## M2022013, Two Rivers groundwater review

Interoffice Memorandum

**Subject: Two Rivers Sand, Gravel and Reservoir Project (Permit No. M-2022-013)  
Application**

Figure 2: Screenshot of portion of Exhibit G: Water Information Map @ 300% zoom, previous version above, most recent version below

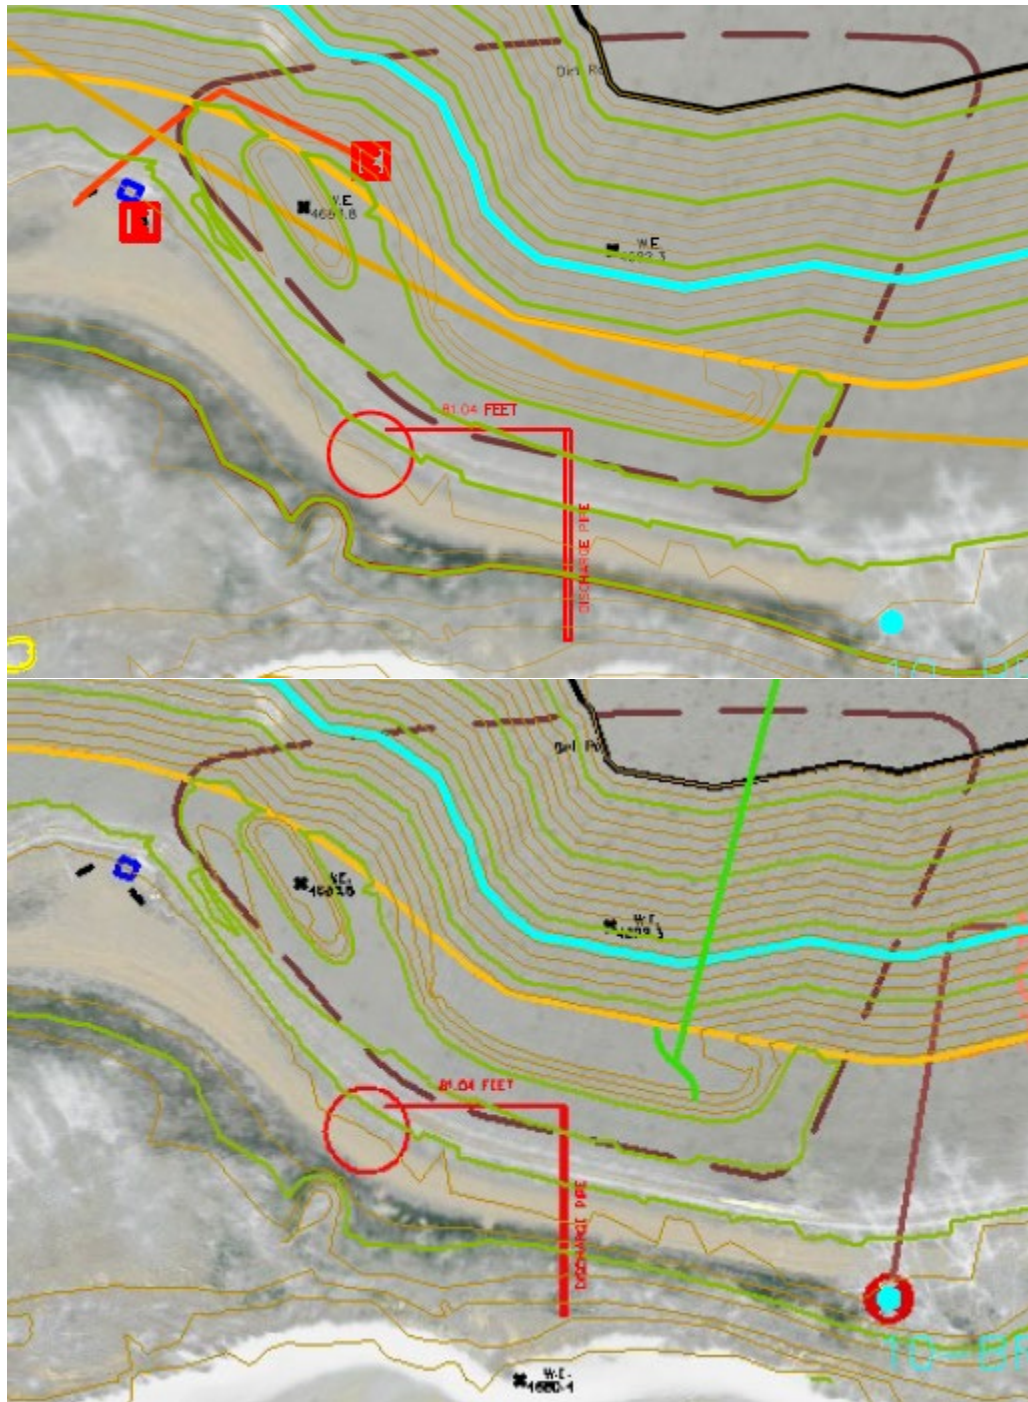
***Several symbols are used on the map but are not identified in the key or labelled on the map, these include:***

- *Inverted red triangles (as shown in figure 1) – symbols for point of access, smaller scale than key*
- *Bold red lines and squares (as shown in figure 2) - removed*
- *Yellow highlighting on contour lines (as shown in figure 2) - removed*
- ***Dashed brown line (as shown in figure 2)***
- *Yellow polygons (as shown in figure 3) - removed*
- ***Blue marks (as shown in figure 3) – partially removed***
- *Fine dashed red lines (as shown in figure 3) - removed*
- *Light red dots (as shown in figure 3) - removed*
- *Black triangles (as shown in figure 3) - removed*

**The revised map addresses some of the points from the previous adequacy review, but not all. In particular, the scale at which some of the labels are drawn renders them illegible, even at 300% zoom. The map has been digitally signed by Peter Christensen, but his qualifying credentials are not given.**
